PIC18(L)F24/25K42 Silicon Errata and Data Sheet Clarification

The PIC18(L)F24/25K42 devices that you have received conform functionally to the current Device Data Sheet (DS40001869E), except for the anomalies described in this document.

The following typographic corrections and clarifications are to be noted for the latest version of the device data sheet (DS40001869E):

Figure 44-5 Clock Timing

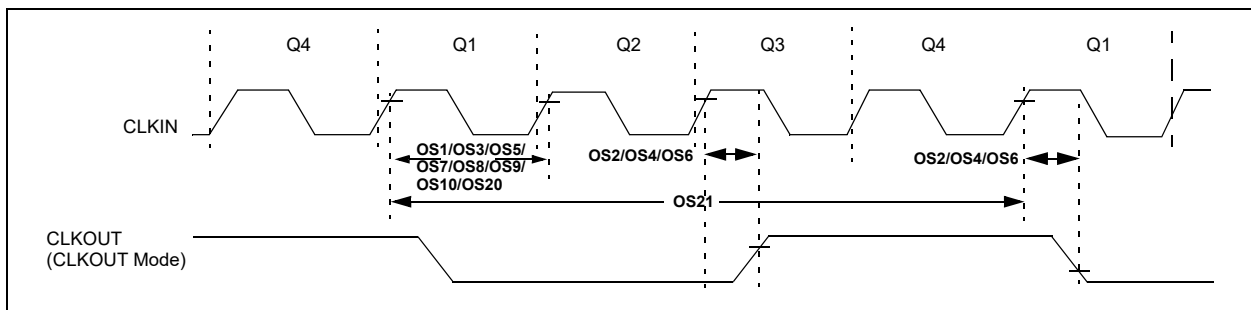
Figure 44-5 incorrectly shows the location of parameters OS1, OS2, OS3, OS4, OS5, OS6, OS7, OS8, OS9, OS10, OS20 and OS21. The correct location for the above-mentioned parameters is depicted in the following figure.
